ATTACHMENT TO WNP-2 CYCLE 2 RELOAD SUMMARY REPORT

TECHNICAL SPECIFICATION CHANGES

MAXIMUM AVERAGE PLANAR LINEAR HEAT
GENERATION RATE (MAPLHGR) VERSUS
AVERAGE PLANAR EXPOSURE
INITIAL CORE FUEL TYPE 8CR103
Figure 3.2.1-1

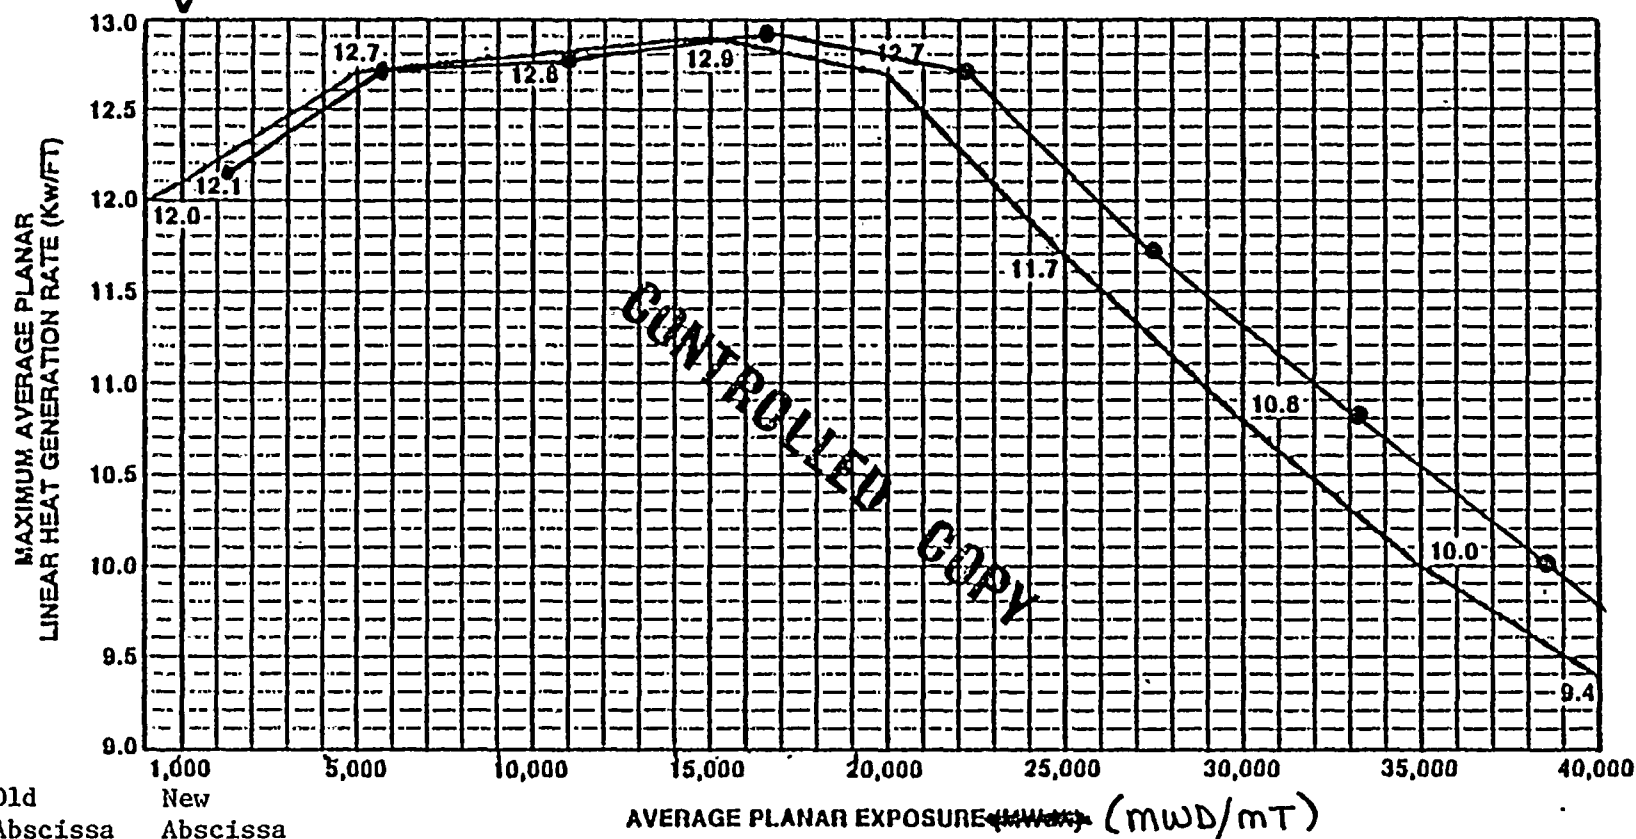
NOTE THAT THE ORDINATE ON THE ORIGINAL
FIGURE IS IN ERROR.

THIS SHOULD BE 0

INFORMATION FOR
NEW CURVE:

Ordinate	Old Abscissa	New Abscissa
12.1	1,000	1,102
12.7	5,000	5,512
12.8	10,000	11,023
12.9	15,000	16,535
12.7	20,000	22,046
11.7	25,000	27,558
10.8	30,000	33,069
10.0	35,000	38,581
9.4	40,000	44,093

MAXIMUM AVERAGE PLANAR LINEAR HEAT
GENERATION RATE (MAPLHGR) VERSUS
AVERAGE PLANAR EXPOSURE
INITIAL CORE FUEL TYPE BCR233
Figure 3.2.1-2

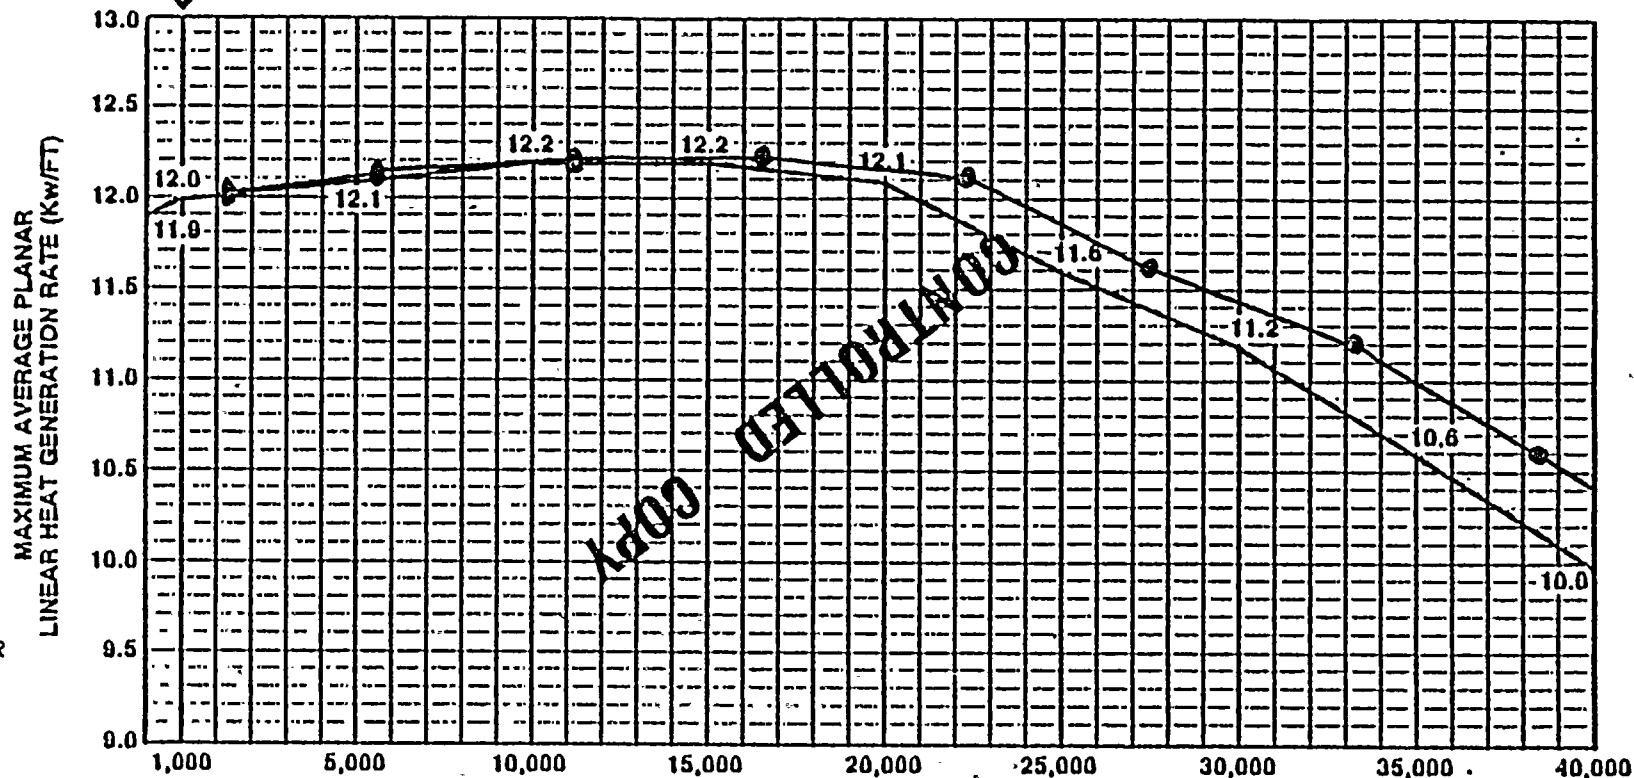
NOTE THAT THE ORDINATE ON THE ORIGINAL
FIGURE IS IN ERROR.

THIS SHOULD BE 0

INFORMATION FOR
NEW CURVE:

Ordinate	Old Abscissa	New Abscissa
12.0	1,000	1,102
12.1	5,000	5,512
12.2	10,000	11,023
12.2	15,000	16,535
12.1	20,000	22,046
11.6	25,000	27,558
11.2	30,000	33,069
10.6	35,000	38,581
10.0	40,000	44,093

MAXIMUM AVERAGE PLANAR LINEAR HEAT
GENERATION RATE (MAPLHGR) VERSUS
AVERAGE PLANAR EXPOSURE
INITIAL CORE FUEL TYPE 8CR711
Figure 3.2.1-3

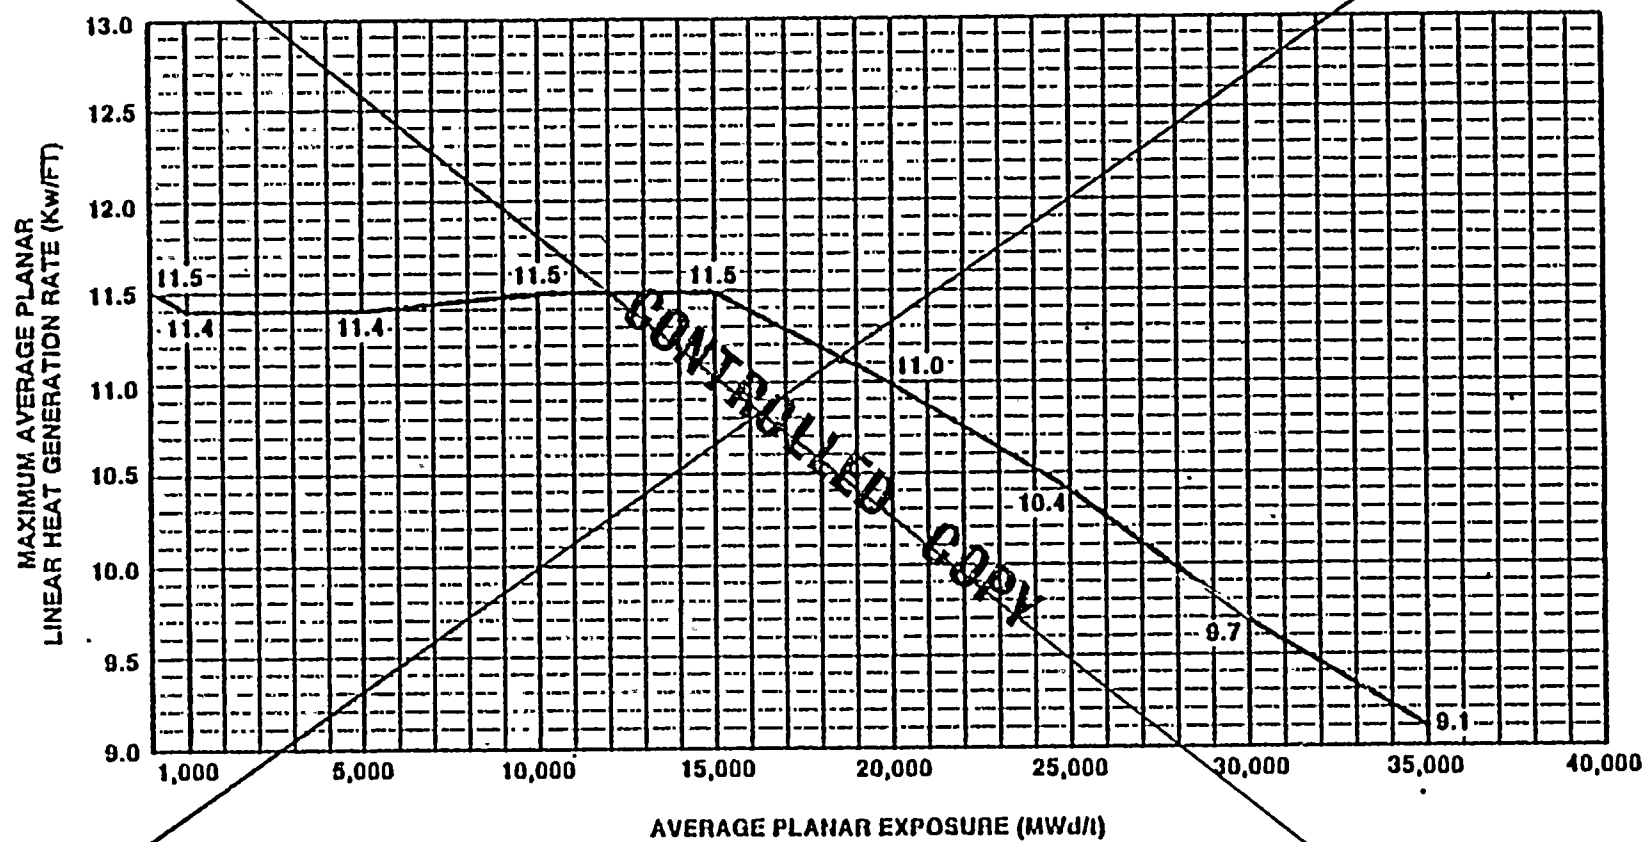
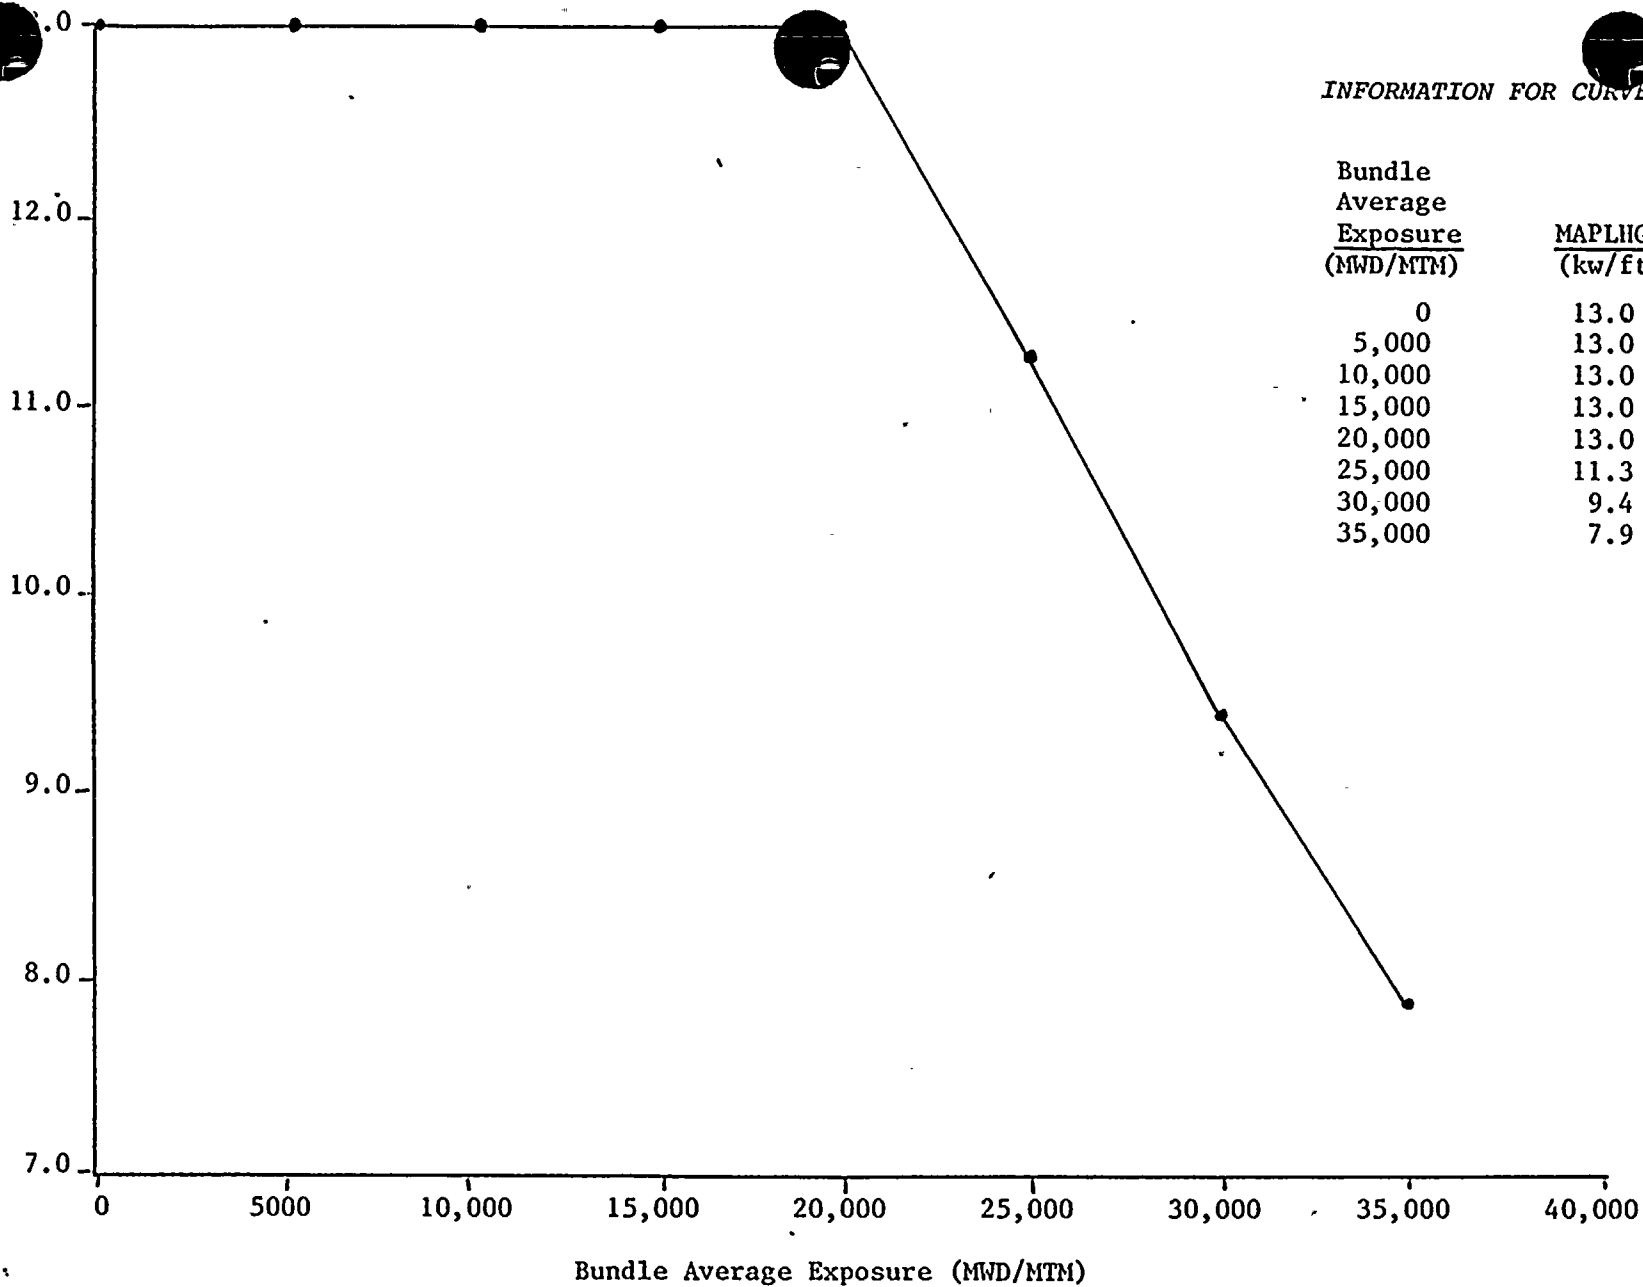
Replace with attached figure

REPLACEMENT FOR FIGURE 3.2.1-3
on page 3/4 2-4

ENC XN-1 Fuel
Figure 3.2.1-3

FIGURE 3.2.3-1
MINIMUM CRITICAL POWER RATIO (MCPR) K_f FACTOR VERSUS CORE FLOW

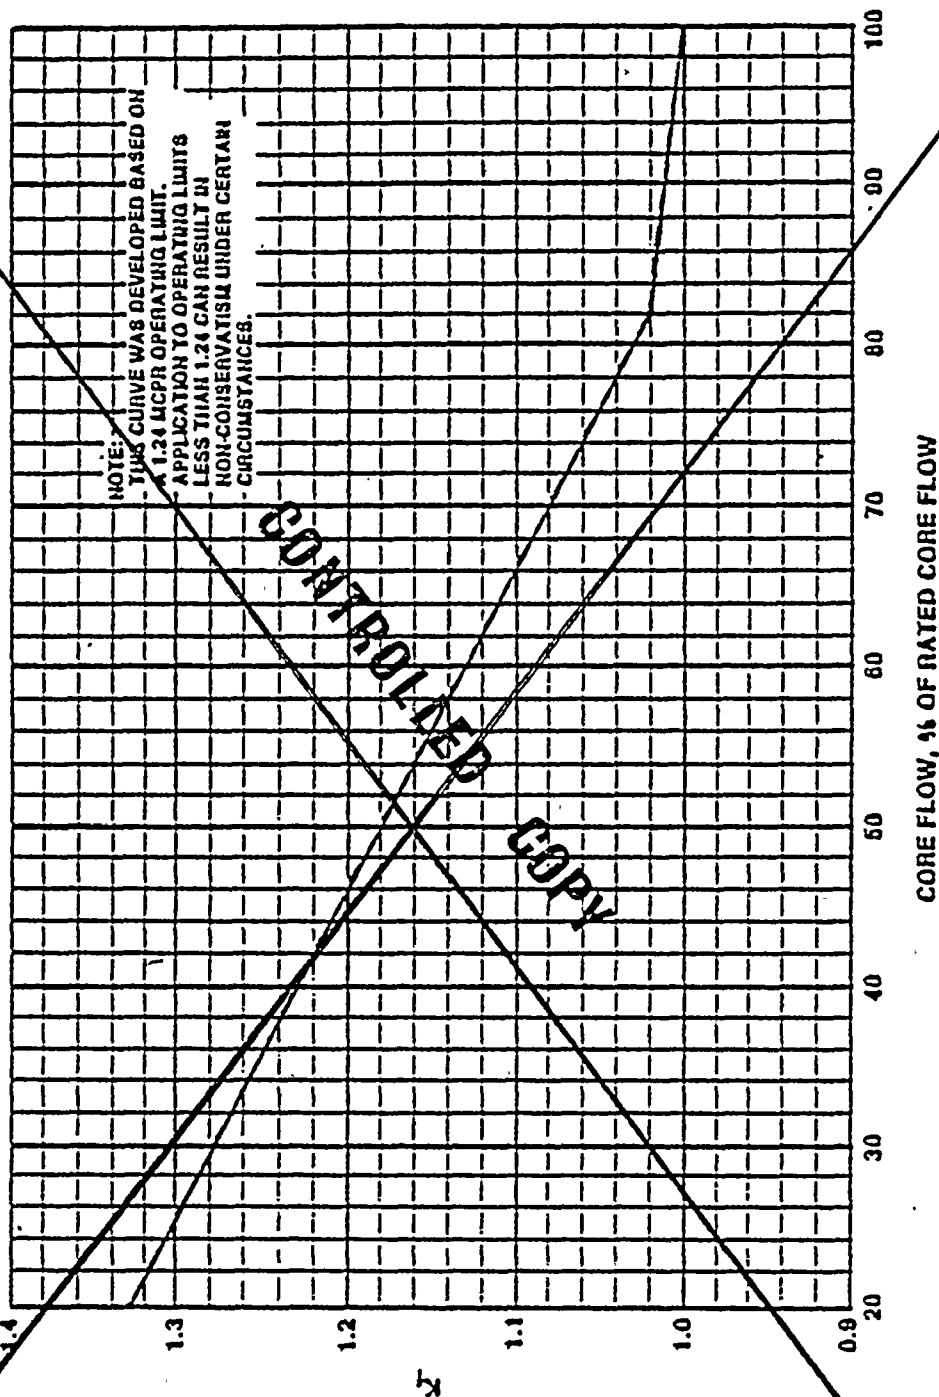
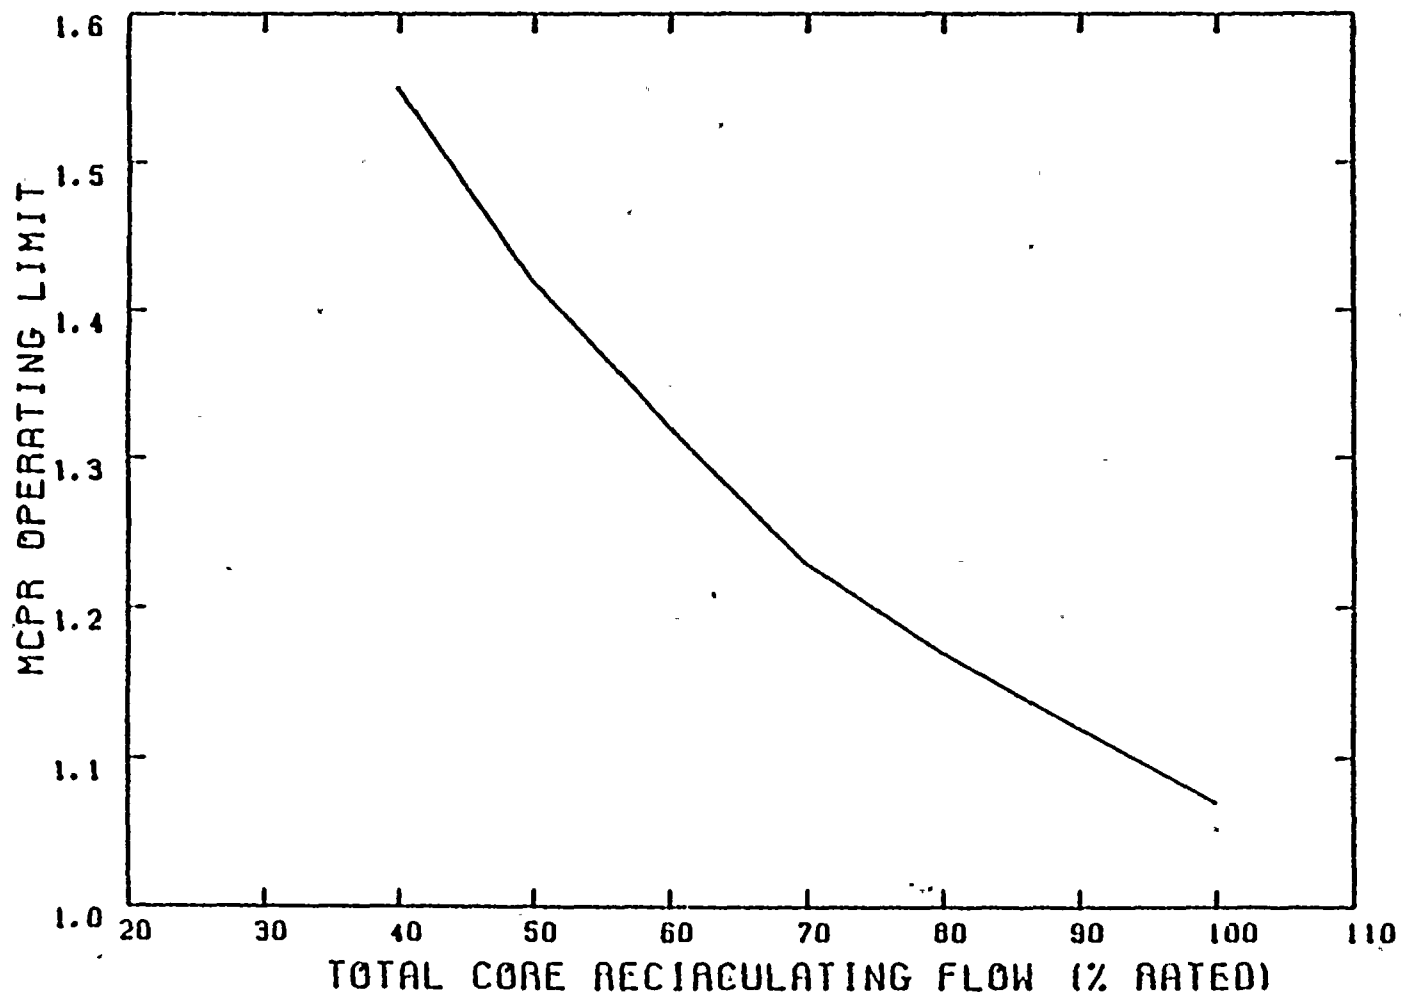
Replace with attached figure

REPLACEMENT FOR FIGURE 3.2.3-1
on page 3/4 2-7

Figure 3.2.3-1

FIGURE 3.2.4-1

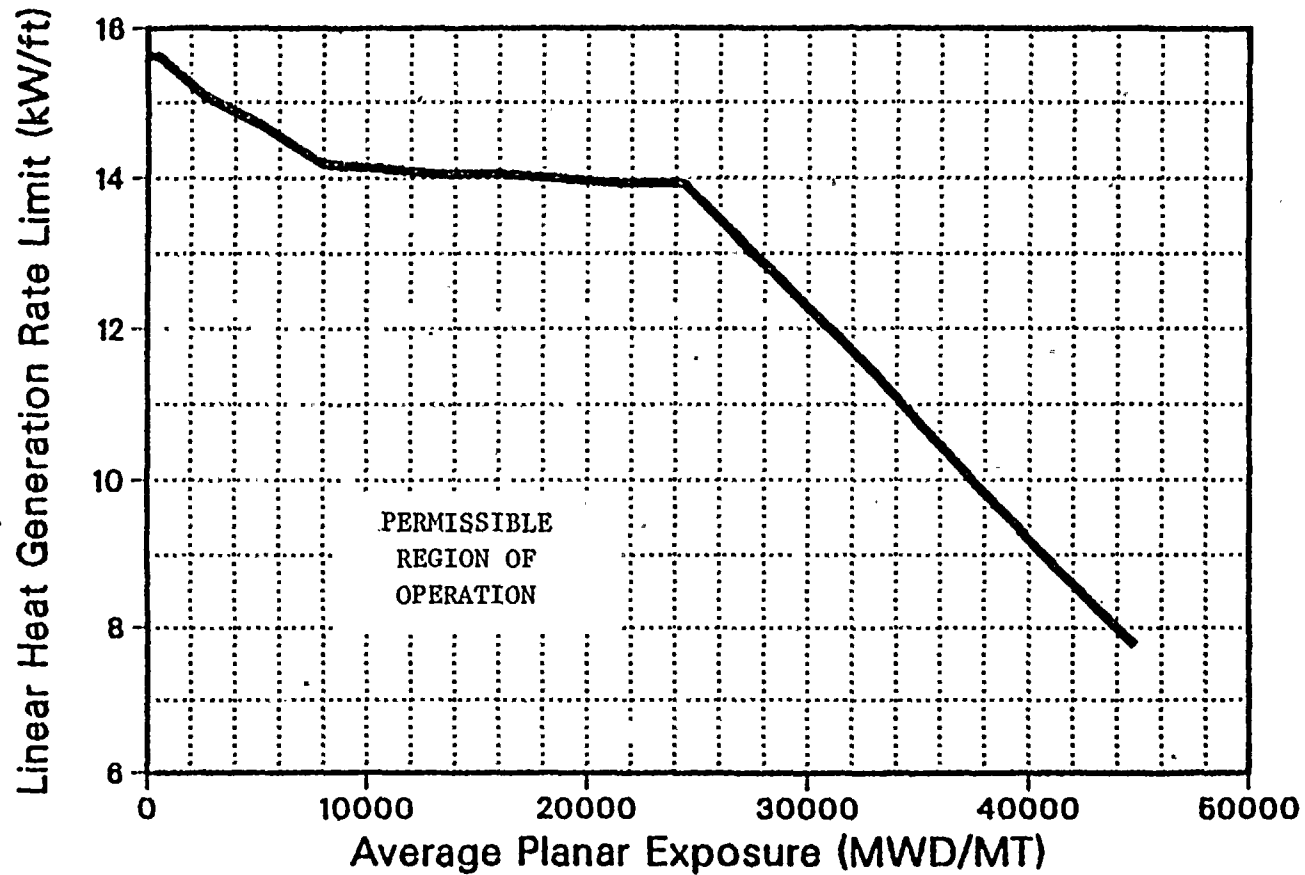
The LHGR for ENE fuel shall not exceed the values shown in Figure 3.2.4-1.
